Submitted on Fri, 13/03/2020 - 14:16  
Submitted by: Anonymous  
Submitted values are:  
Submission Type:I am making a personal submission  
First Name: Andrew  
Last Name: Gayed  
Name Withheld: No

2 November 2018

**RE: CONCEPTUAL REGIONAL FLOOD MITIGATION STRATEGY, LAND AT [REDACTED] [REDACTED]  
[REDACTED] BRINGELLY – SOUTH CREEK PRECINCT, ROSSMORE  
NSW**

**FIGURE 1: CURRENT ZONING PROPOSAL**

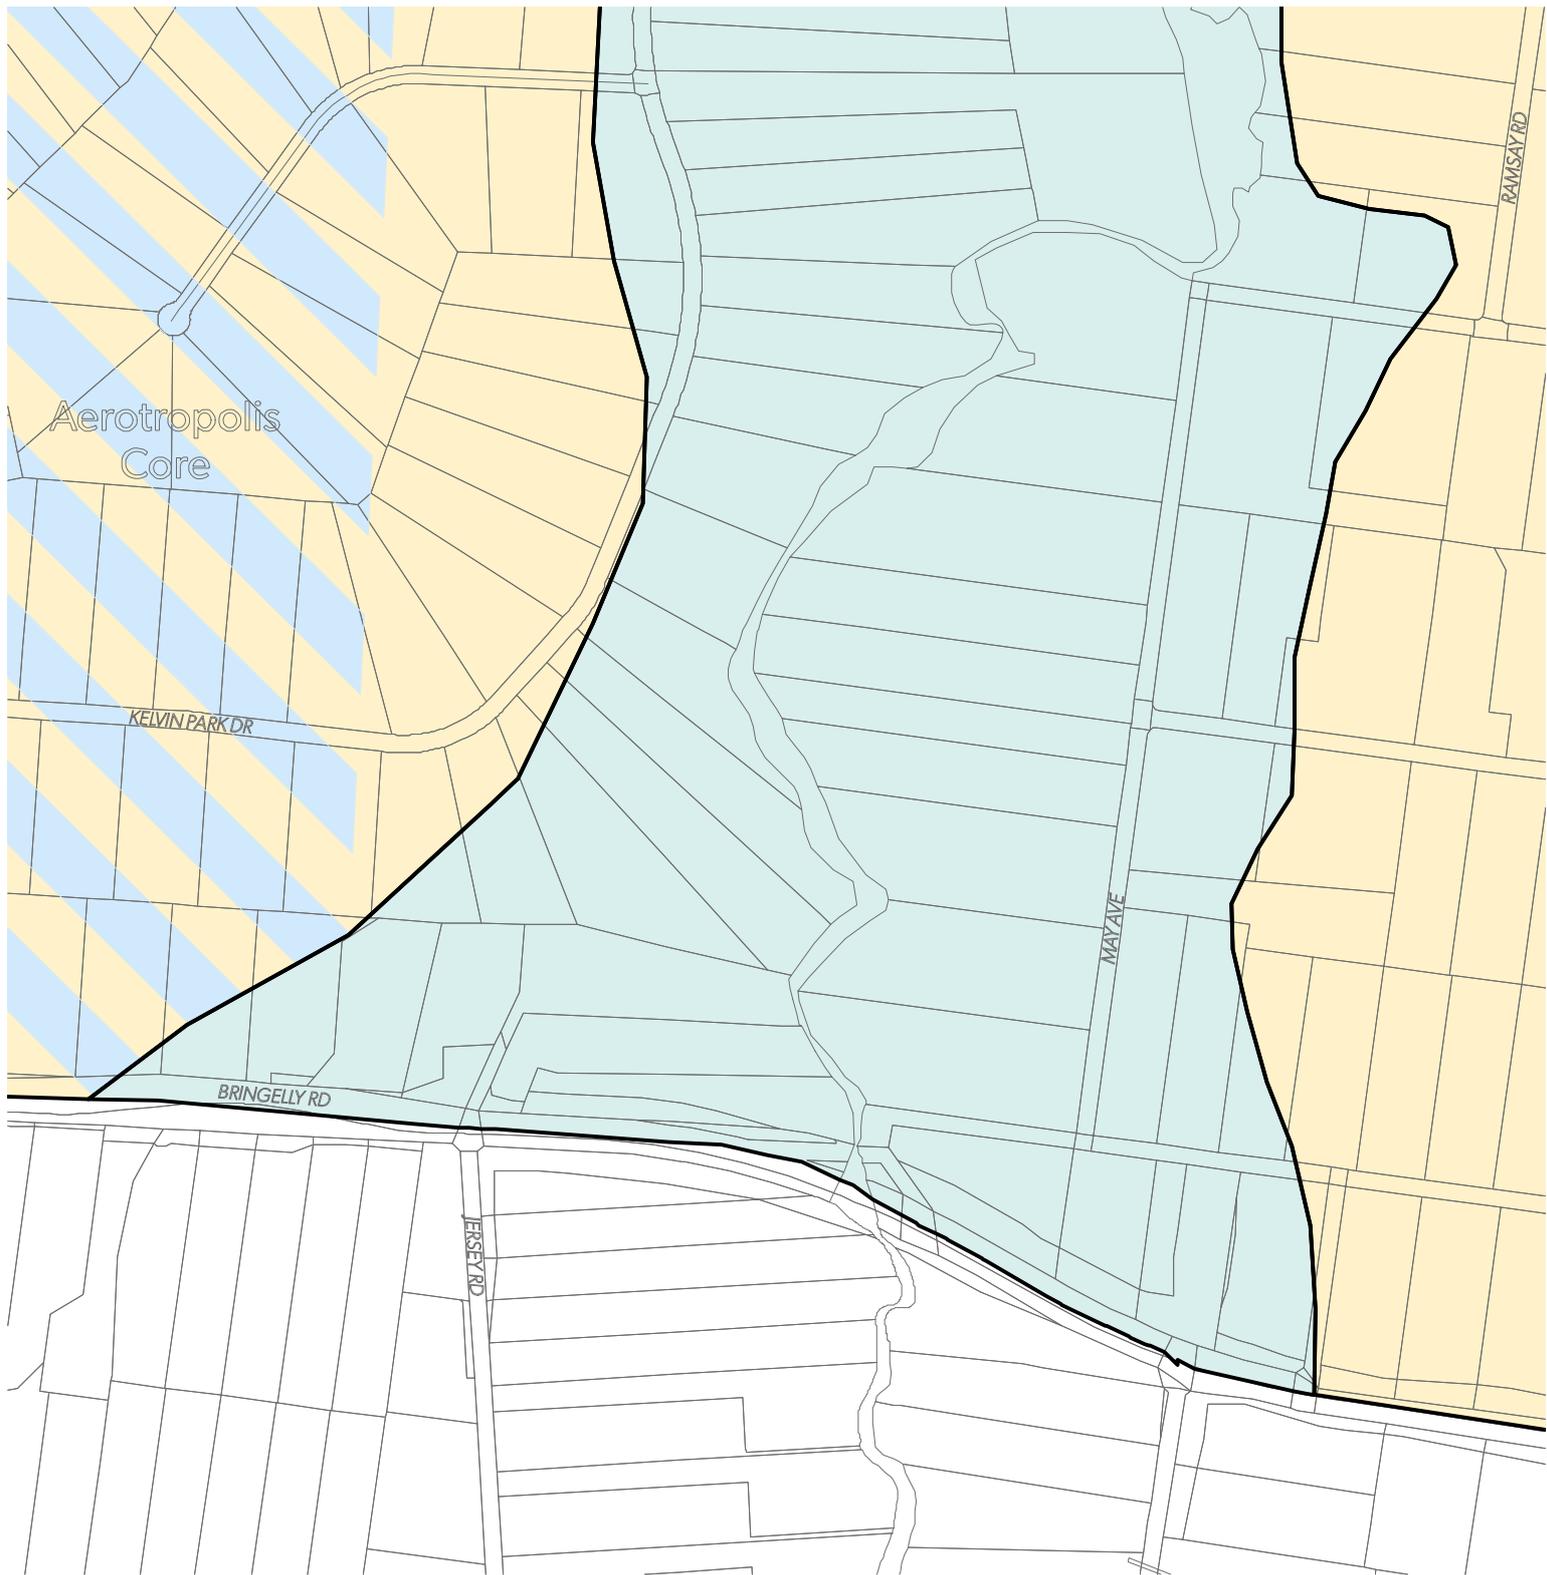
The current proposed general zoning category of 'urban' and 'non-urban' land are provided at Figure 1. We observe the following in respect of these boundaries:

1. The non-urban land encompasses flood liable land to the PMF and in many areas, even land that is above the PMF.
2. The non-urban land is centred on South Creek and presents as a corridor which varies between say 700-800 m in width. The width is far more than is necessary to carry upstream stormwater flows. It is likely that if such a width were ultimately adopted, that it may be difficult to achieve a number of the precinct objectives such as a useable interface between urban and non-urban land and provision of efficient connections across water ways.

3. It is our view that a narrow 'environmental corridor' which would range say between 250-450 m in width, would be more than adequate to carry upstream stormwater flows, as well as being capable of satisfying the precinct objectives. A narrower corridor would also mean that fewer properties would ultimately be integrated into the non-urban category, this translates into better efficiencies in achieving environmental outcomes within the corridor.

**FIGURE 2: PROPOSED CONCEPT FLOOD MITIGATION STRATEGY AND ALTERNATIVE ZONING FOR PRECINCT**

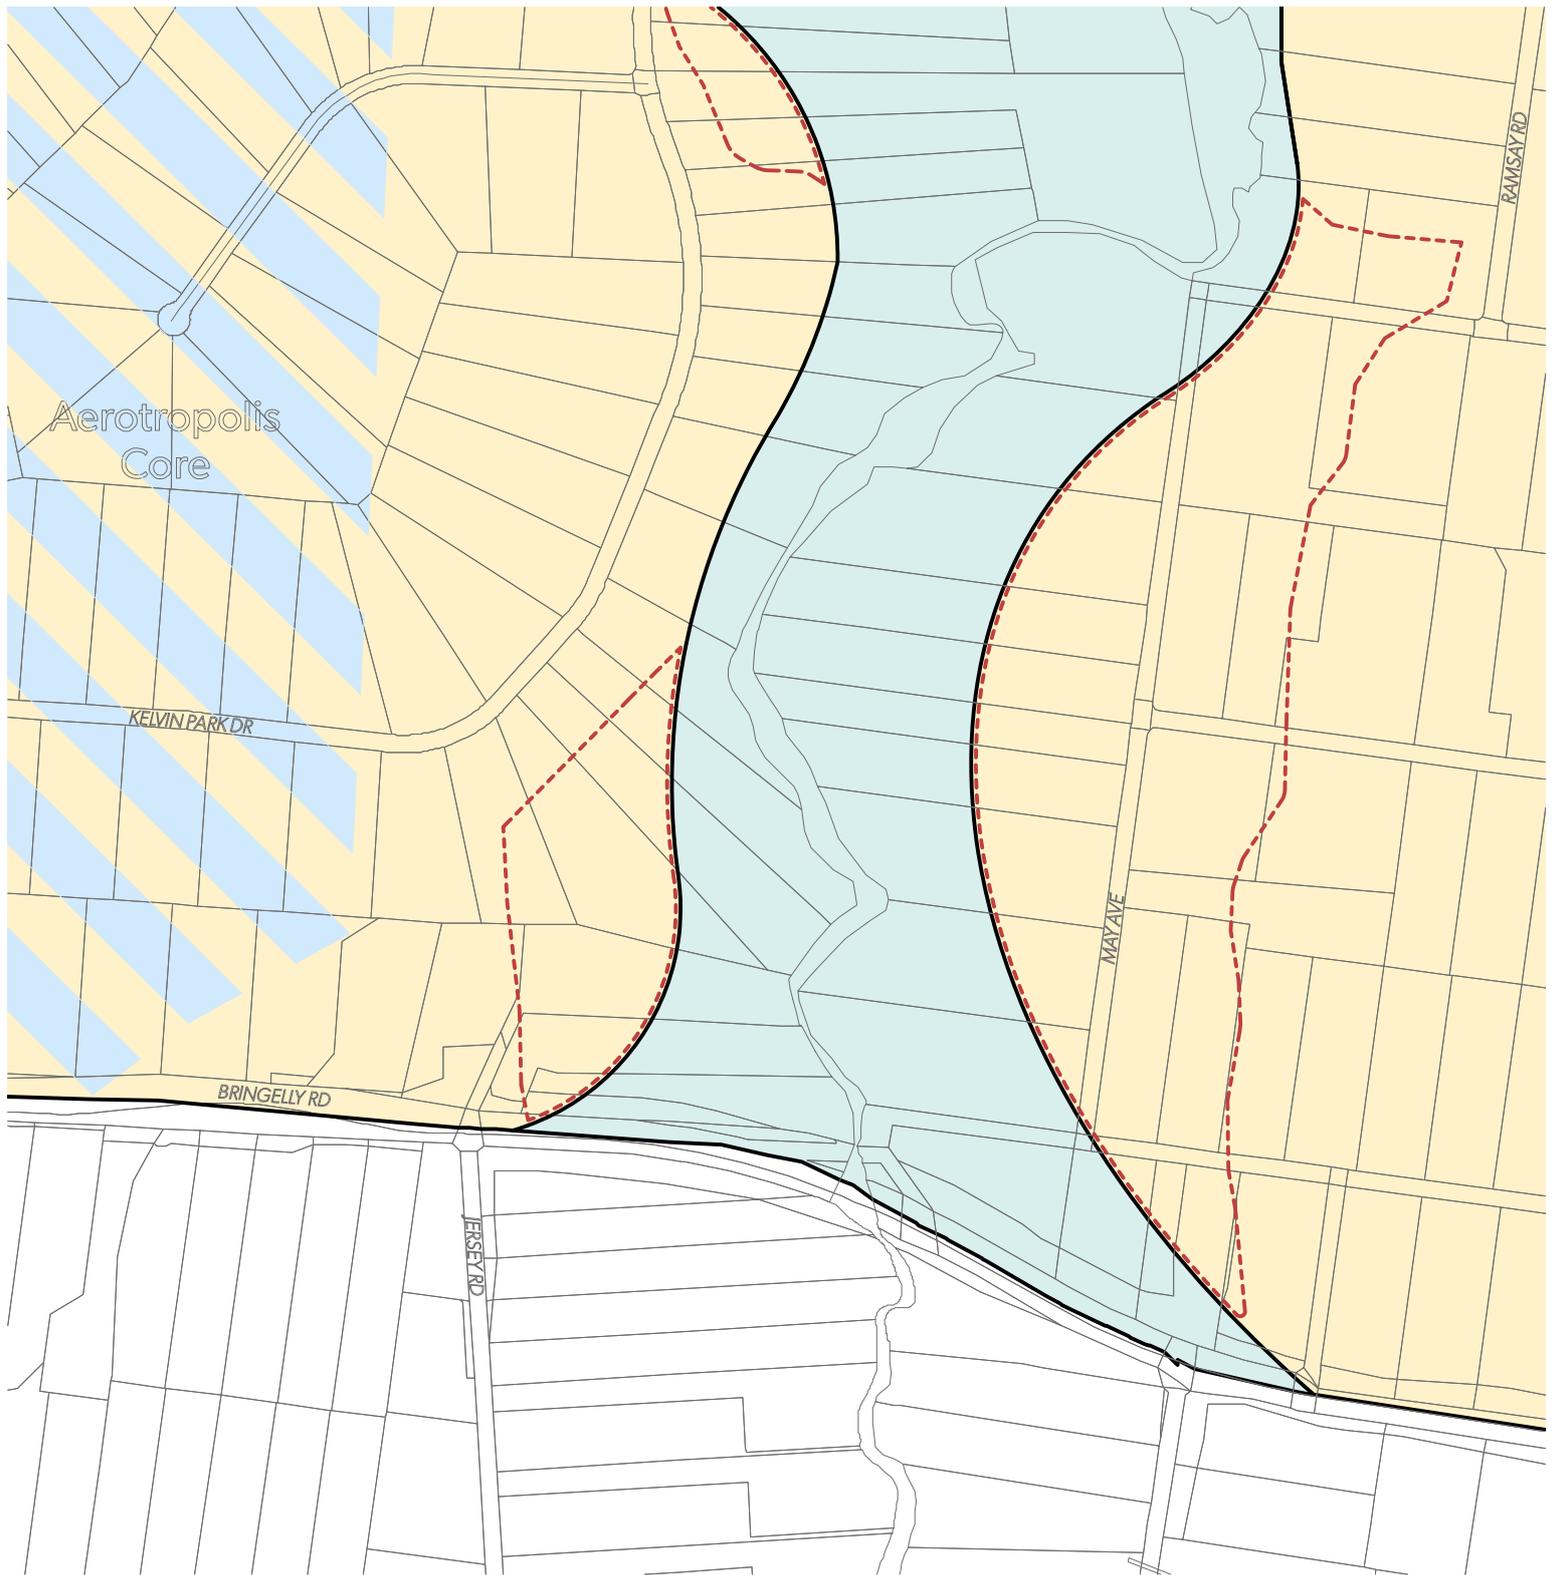
The concept FMS is provided at Figure 2 and Figure 3. Figure 2 provides a plan of the alternate broad 'urban' and 'non-urban' zoning categories, also indicating the areas where earthworks would be required to achieve ground levels at the PMF. Figure 3 provides a typical schematic section through the ultimate environmental corridor. The following comments are made in respect of the alternative scheme:

1. The alternate scheme will deliver a better opportunity to meet the precinct objectives.
2. The alternate scheme would ensure adequate conservation and rehabilitation of riparian land.
3. The alternate scheme would enable efficient connectivity between urban and non-urban land.
